REQUIRED INSPECTION NOTICE

DATE: JULY 31, 1998
RIDE: DRAGON WAGON
SUBJECT: ROD END COUPLER THREADS
REQUIRED COMPLIANCE: MANDATORY
COMPLETION DATE: IMMEDIATELY

SUBJECT: Wisdom's Dragon Wagon/Go Gator/Scooper Jet/Clatterpillar/Minor Mike

RE: DRAGON WAGON (SMALL CARS)

WISDOM INDUSTRIES Merino, CO 80741		
SCALE: NTS	APPROVED BY:	DRAWN BY: JLC
DATE: 7-19-96		REVISED:
DESCRIPTION CAR HITCH		
EQUIPMENT: COASTERS		DRAWING NUMBER DWG #

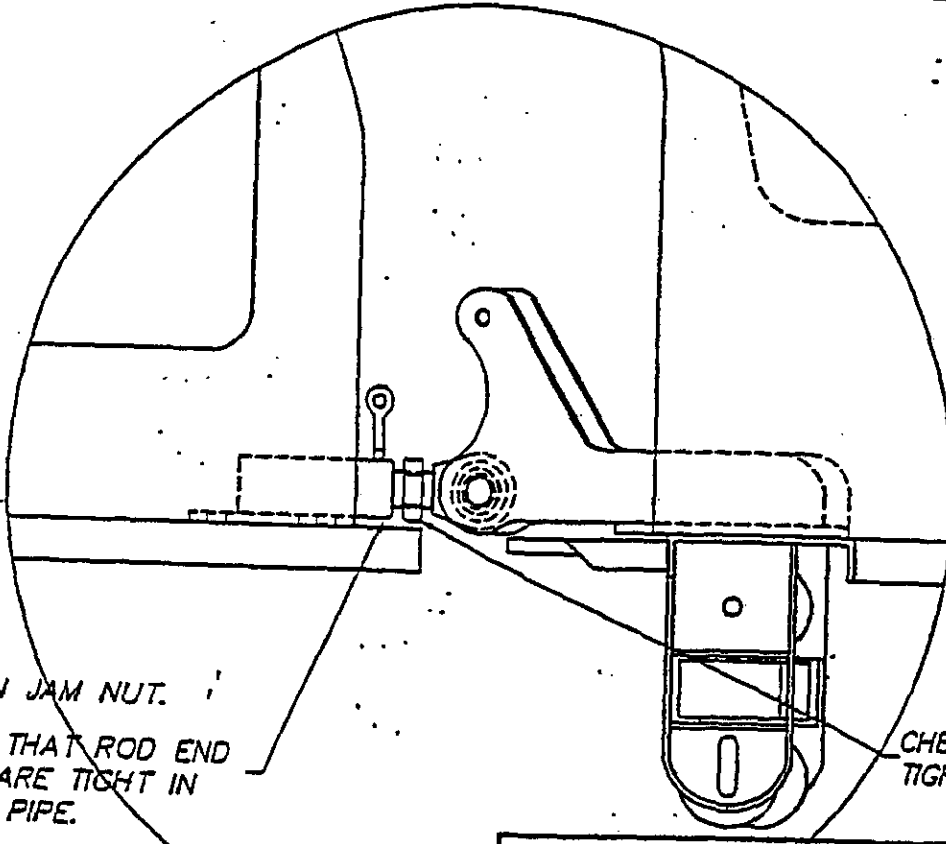
One coaster has experienced wear on the threads on the rod end connecting the cars together. The wear is caused by the lock nut loosening and allowing the rod end to work back and forth in the coupler mount. To prevent the possibility of the rod end pulling out of the mount, check the threads in all rod end couplers for wear and replace any that are worn.

1. LOOSEN JAM NUT.
2. CHECK THAT ROD END THREADS ARE TIGHT IN MOUNTING PIPE.
3. TIGHTEN JAM NUT.

1. Loosen jam nut on rod end.
2. Raise and lower the front of the car that the rod end is attached to.
3. Look for looseness or movement of the thread end inside the coupling mount as the front of the car is raised and lowered.
4. If no looseness is observed retighten the rod end.
5. If the threads are loose remove the rod end and replace.
6. Retighten the rod end.

1. Block up front of car.
2. Remove 1 inch connecting bolt.
3. Disconnect safety chain.
4. Push car ahead to allow access to rod end.
5. Loosen lock nut.
6. Unscrew rod end from coupler.
7. Screw lock nut from original rod end onto new rod end.

8. Check for looseness in the coupler by moving the rod end up and down.
9. If it is still loose the coupler may need to be replaced.
10. Tighten lock nut.
11. Reconnect cars together with 1 inch bolt and lock nut.
12. Connect safety chain.
13. Check that the lock nut is tight.
14. Remove blocks and check track for objects that will stop the train.
15. Test run ride.
16. Check that the jam nut is tight daily.

CHECK JAM NUT FOR TIGHTNESS DAILY.

WISDOM INDUSTRIES Merino, CO 80741		
SCALE: NTS	APPROVED BY:	DRAWN BY: JLC
DATE: 7-19-96		REVISED:
DESCRIPTION CAR HITCH		
EQUIPMENT: COASTERS		DRAWING NUMBER DWG #

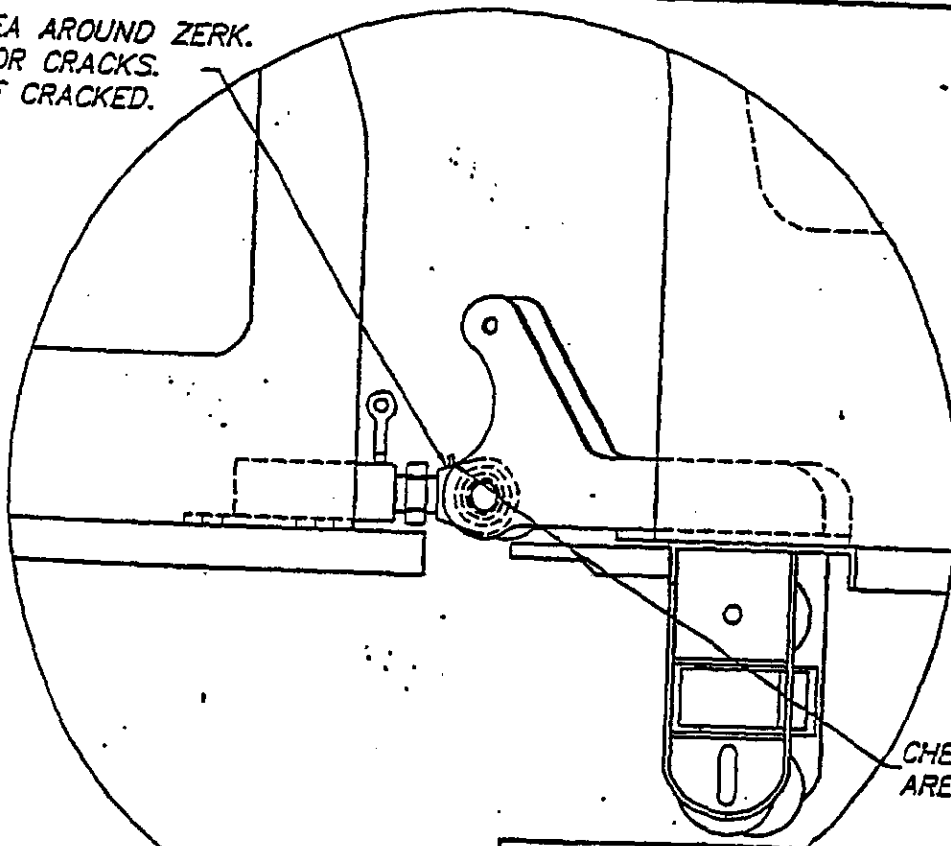
One coaster has has one rod end crack at the grease zerk hole. Inspect the rod end, between the cars for cracking in the grease zerk area.

CLEAN AREA AROUND ZERK.
INSPECT FOR CRACKS.
REPLACE IF CRACKED.

1. Thoroughly clean the area around the grease zerk.
2. Inspect the area around the ground zerk for cracks.
3. If there is a question about cracking use a dye penetrant kit to check for cracks.
4. If no cracks are found include a check of the grease zerk area in the daily inspection of the ride.
5. If the rod end is cracked replace the rod end.

1. Block up front of car that the rod end is going to be replaced on.
2. Remove 1 inch connecting bolt.
3. Disconnect safety chain.
4. Push car ahead to allow access to rod end.
5. Loosen lock nut.
6. Unscrew rod end from coupler.
7. Screw lock nut from original rod end onto new rod end.
8. Screw in new rod end.

NOTE: The threads must be screwed in at lease 1 to 1.25 inches into the coupler.

9. Screw new rod end into coupler.
10. Tighten lock nut.
11. Reconnect cars together with 1 inch bolt and lock nut.
12. Connect safety chain.
13. Check that the lock nut is tight.
14. Remove blocks and check track for objects that will stop the train.
15. Test run ride.
16. Check that the jam nut is tight daily.

CHECK GREASE ZERK
AREA FOR CRACKS.

NOT TO SCALE

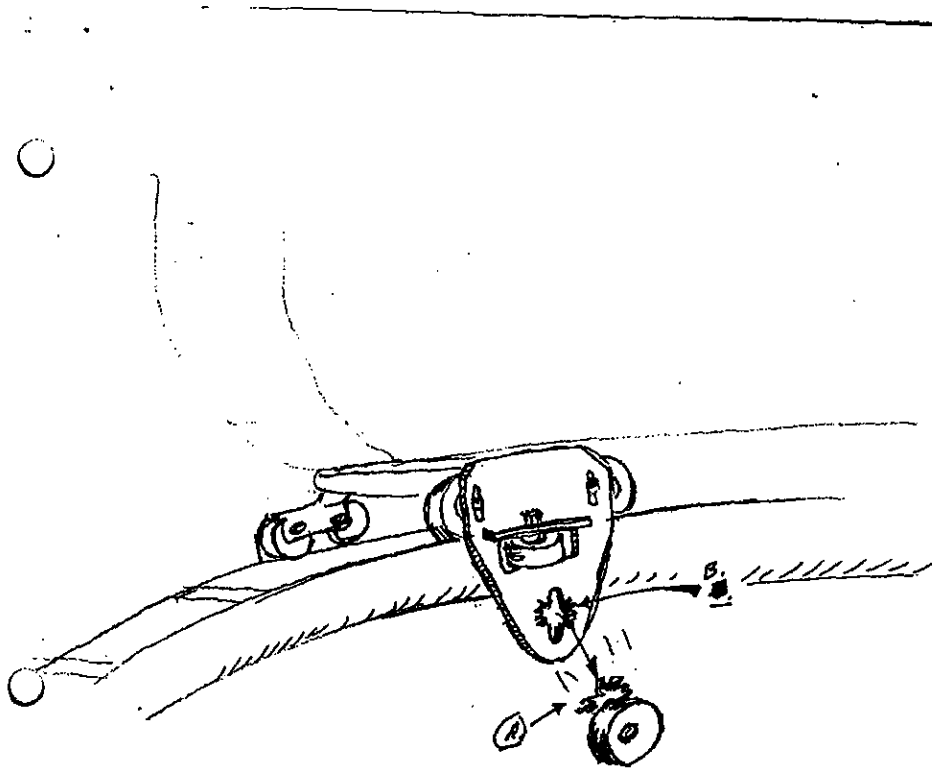
Carlos Corvo inspected Crown's Dragon Wagon and found the bottom wheel had broken loose, and came completely through the adjustment slot, due to metal fatigue/incorrect bolt size/incorrect nut/incorrect washer or combination of all four. (See diagram)

Removing the bottom wheels from the remaining tubs Carlos found seven out of the remaining eight had "v" shaped cracks (see diagram) emanating from the adjustment slot, and one of the seven was almost ready to fail.

Returning home from Crown Carlos stopped and looked at Gargano's Dragon Wagon. He found one out of seven of the wheels cracked.

Until we hear further from Wisdom we will require the operators remove the bottom wheel, clean the area of grease and dirt, so that we can more closely visually inspect for cracks. There is an oversized washer that, we believe, is to be used on this wheel. If an undersized nut/bolt or washer is used it may exacerbate the situation.
